Bulletin Type.....: Field Fix (M)
Bulletin No.....: TS-M119
Bulletin Name.....: Hydraulic Hoses Of Ras System
Bulletin Ref No.....: 700003210
NHTSA.....:
Release Date.....: 20.06.2017
Expiry Date.....: 20.06.2018
Vehicle Model.....: TS45
Fiat Rate Code.....: TSM119
Flat Rate Time.....: 180'

Subject: TS45 Tag Axle RAS system hydraulic hose replacement

Summary: This technical service bulletin gives instruction about how to replace the hydraulic hoses of TS45 tag axle RAS system

Figure-1

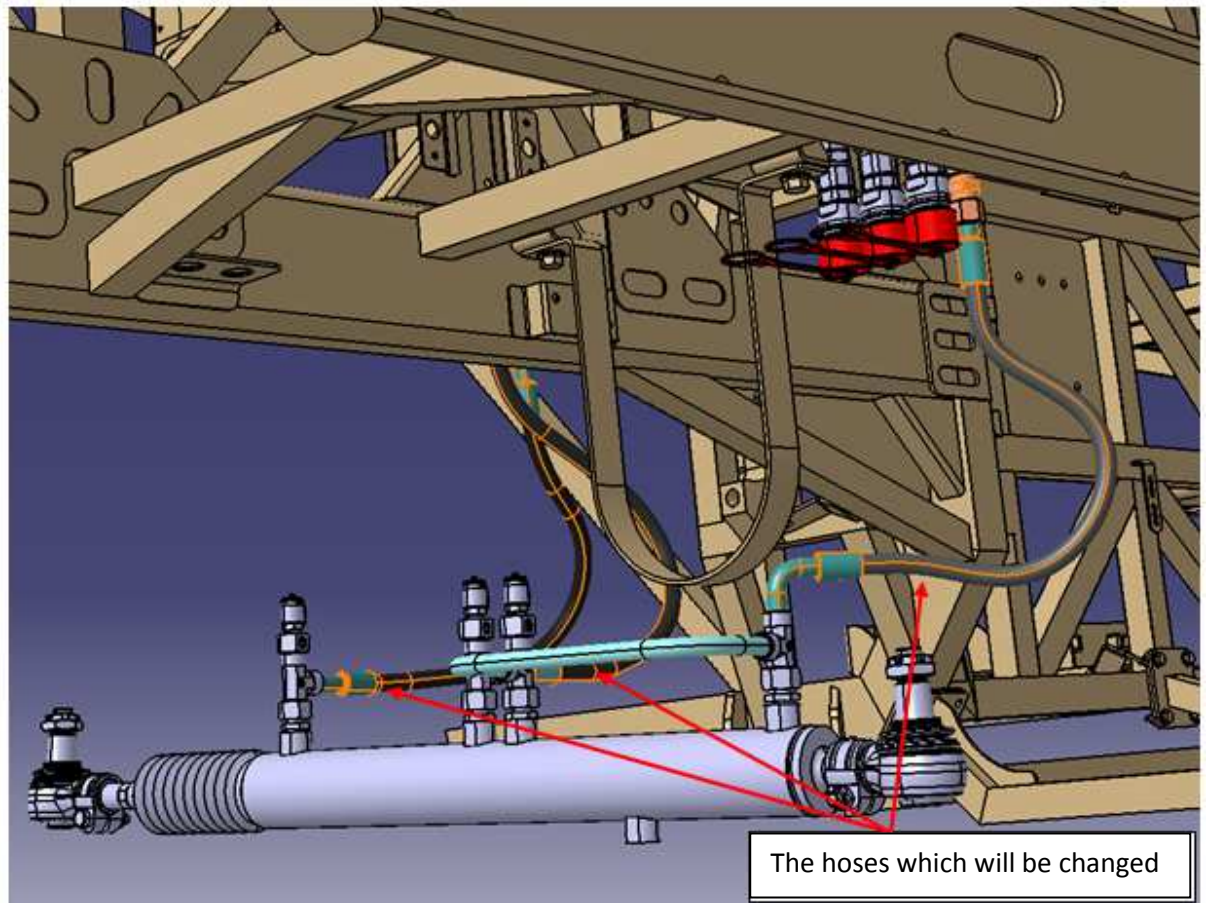
- 1- Pull the vehicle to the pit or lift.
- 2- Figure-1 shows the working area and hoses with the red arrows which will be changed with the new ones.

Figure-2

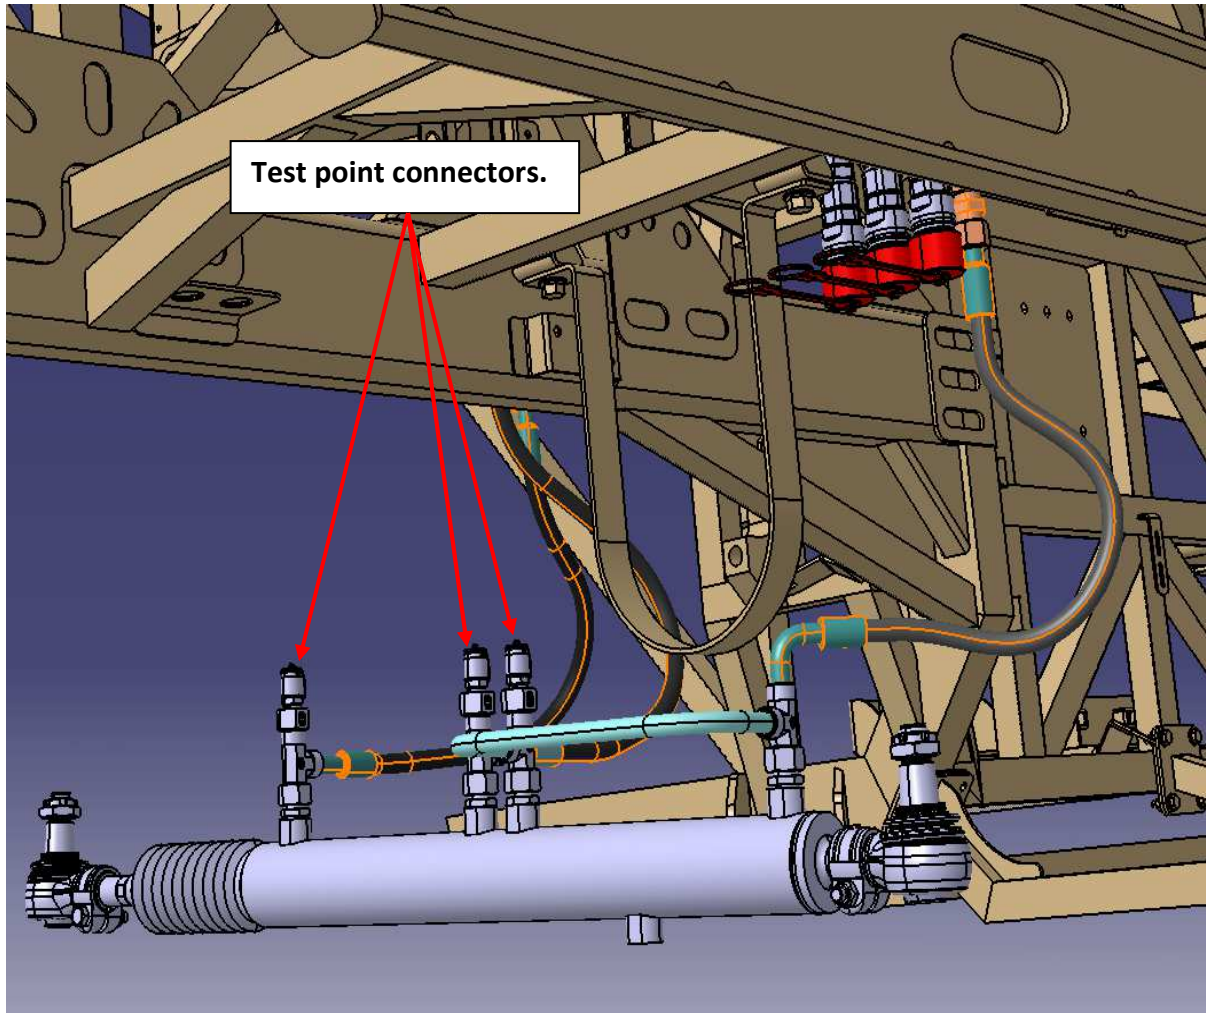
NOTE: The RAS System hydraulic line pressure is approximately 18 bar (261 Psi). In this regard, be careful when you work on the RAS system hydraulic line. Before starting the disassembly process, decrease the system pressure by using test point connectors which is marked with red arrows on Figure-2.

Figure-3

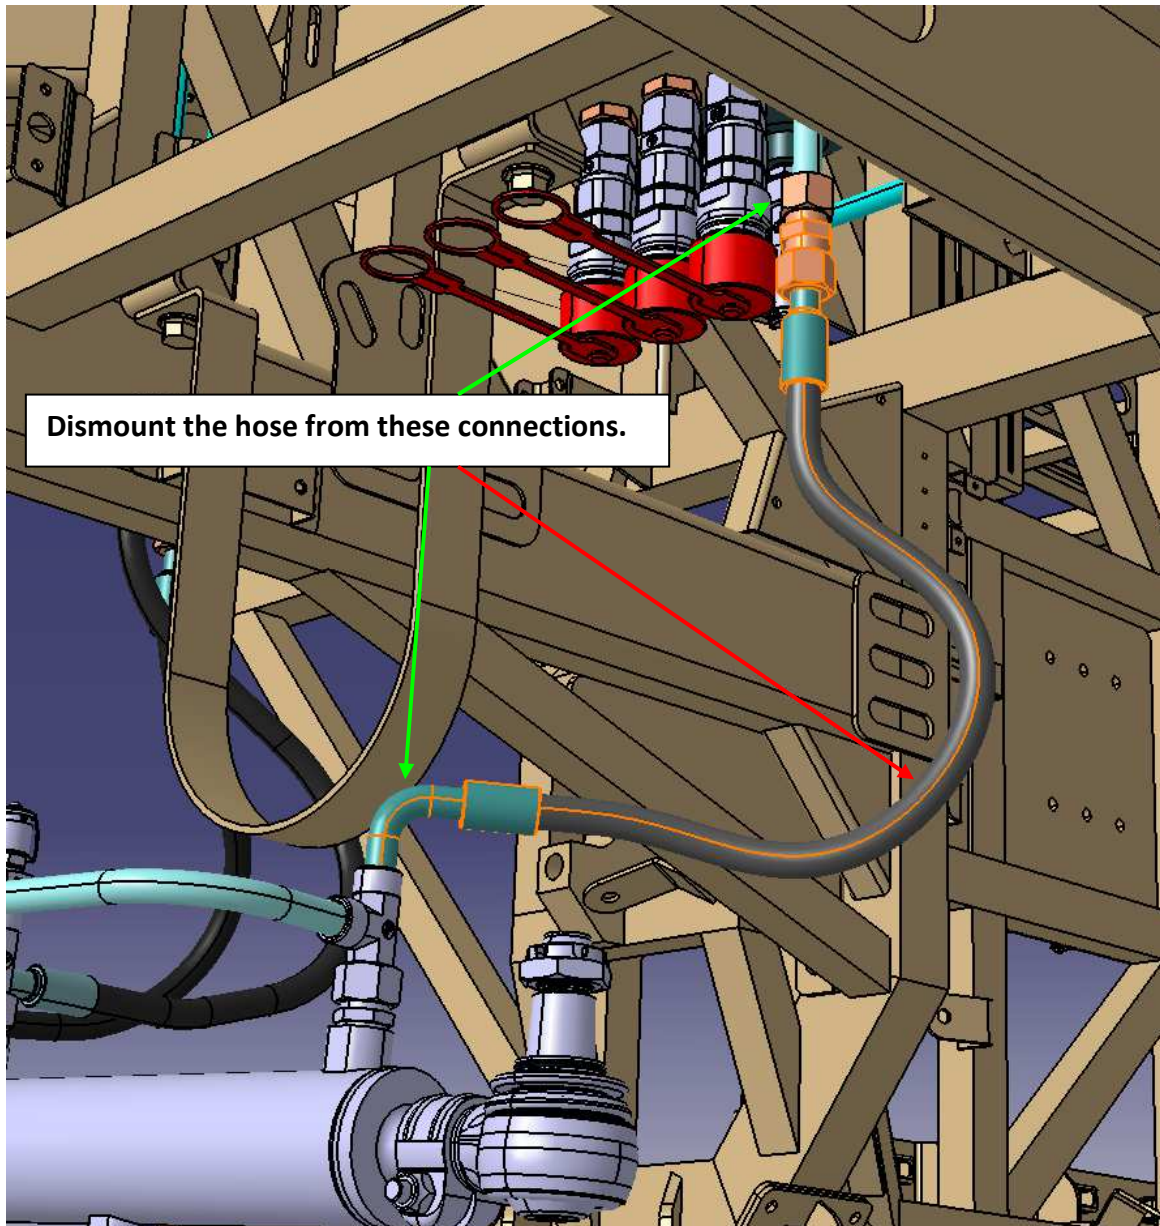
3. Dismount the 9630-06Y hose and 61102-90000-25 straight union then mount the 9630-34Y hose as replacement of these parts (see the Figure-3).

Figure-4

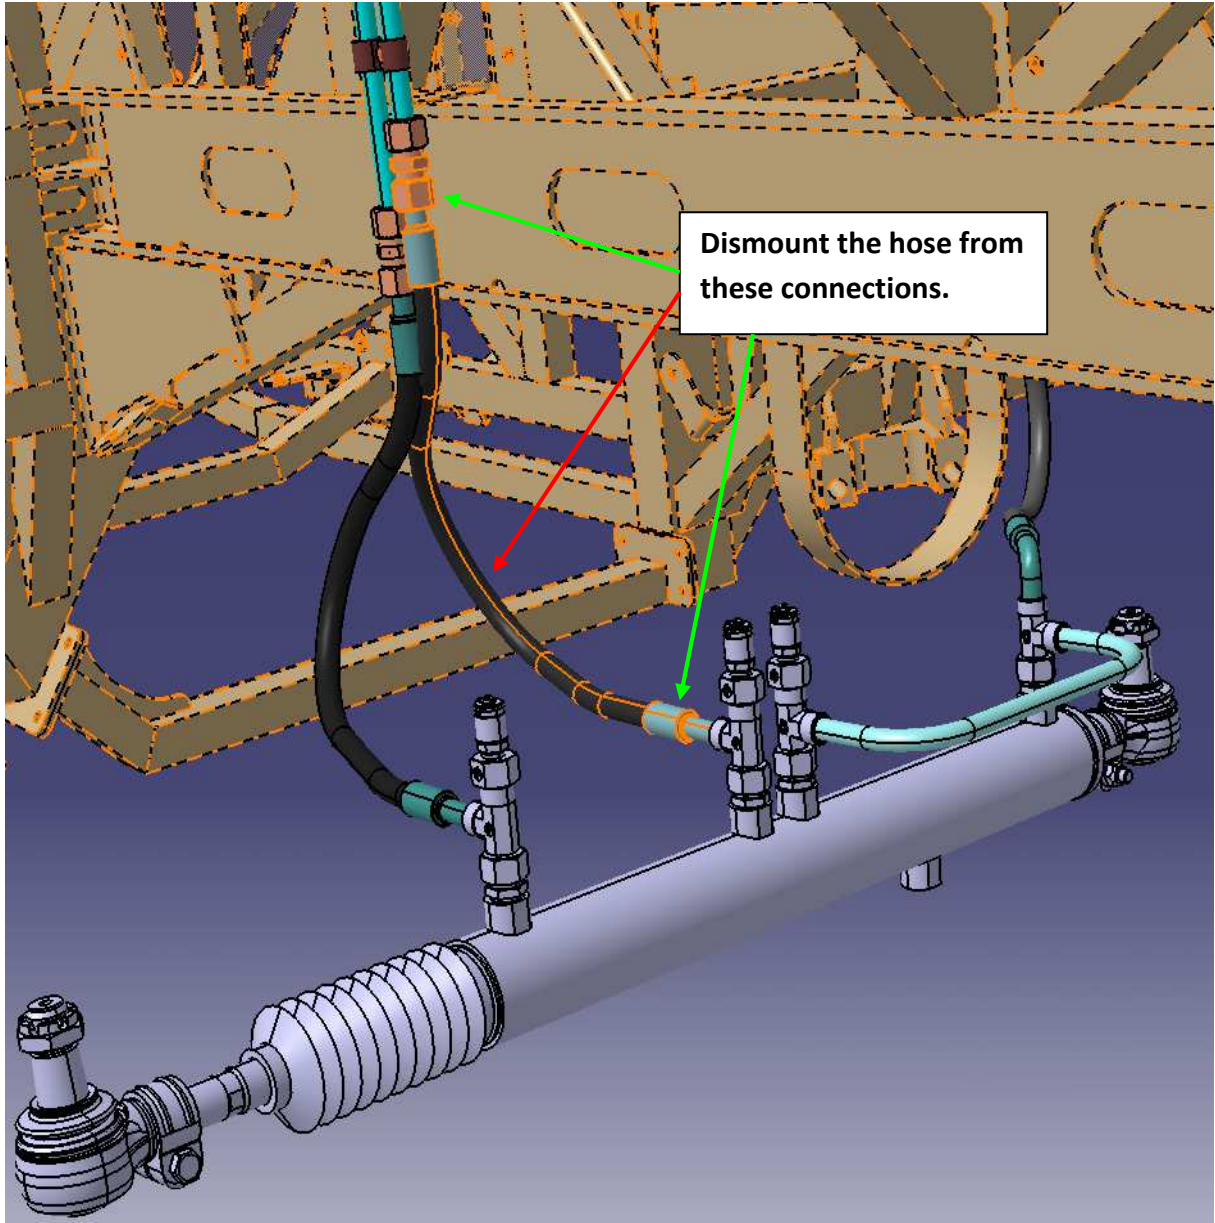
4. Dismount the 9630-04Y hose and 61102-90000-25 straight union then mount the 9630-32Y hose as replacement of these parts. (see the Figure-4)

Figure-5

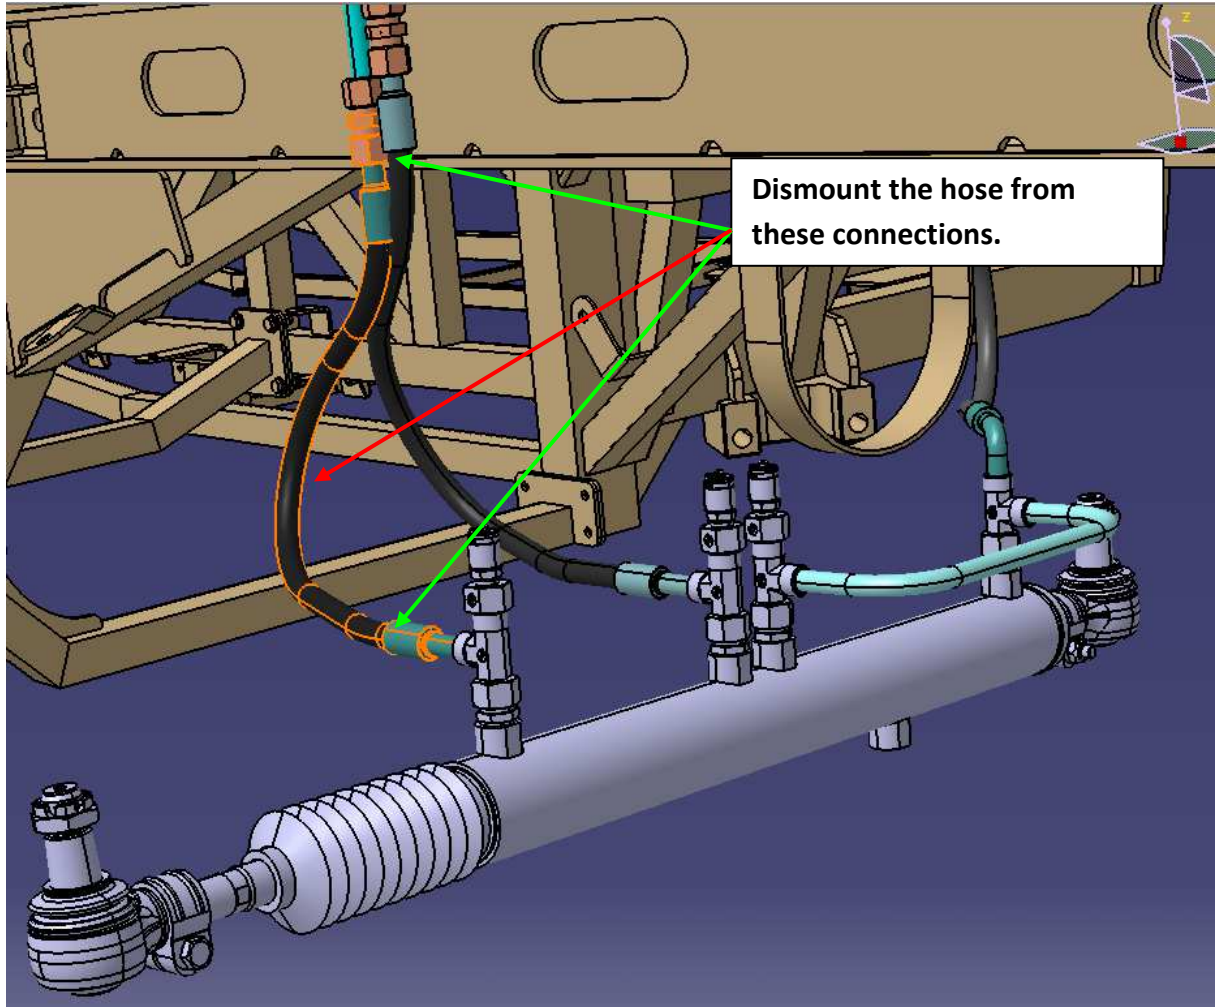
5. Dismount the 9630-05Y hose and 61102-90000-25 straight union then mount the 9630-33Y hose as replacement of these parts.(see the Figure-5)
